REFERRAL REPORT

Report Date: March 30, 2021
Contact: Yardley McNeill
Contact No.: 604.873.7582
RTS No.: 14396
VanRIMS No.: 08-2000-20
Meeting Date: April 13, 2021

TO: Vancouver City Council
FROM: General Manager of Planning, Urban Design and Sustainability
SUBJECT: CD-1 Rezoning: 8655 Granville Street

West Elevation (lane)

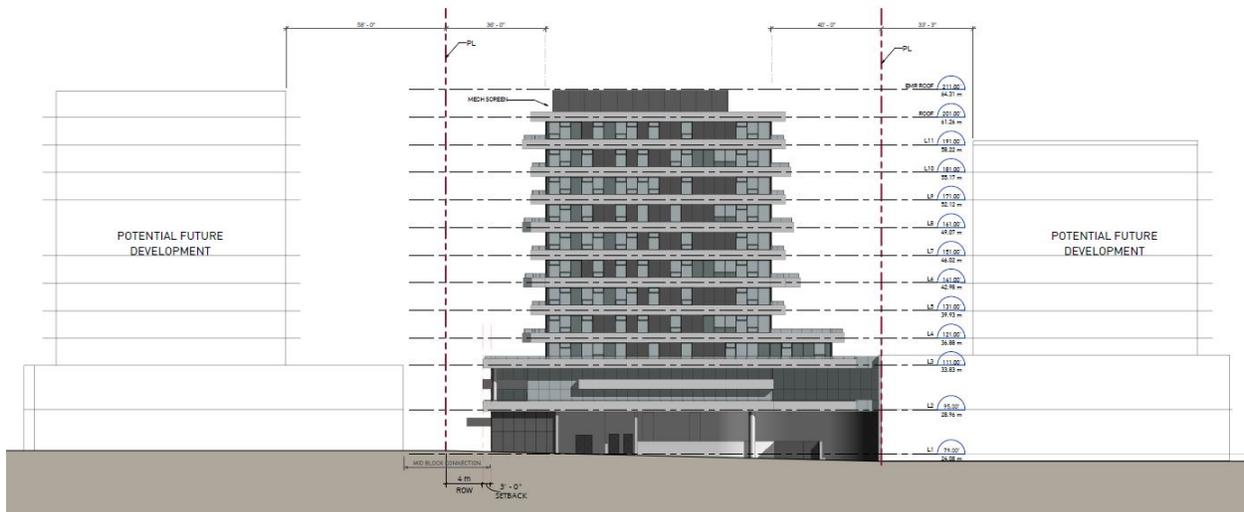
- 1.5 Consider additional design development to the west elevation to add visual interest, improve unit livability, and address solar gain.

Note to Applicant: The west elevation has small operable windows. Consider enlarging these for improved cross-ventilation. As well, exterior shading devices may be introduced to add articulation.
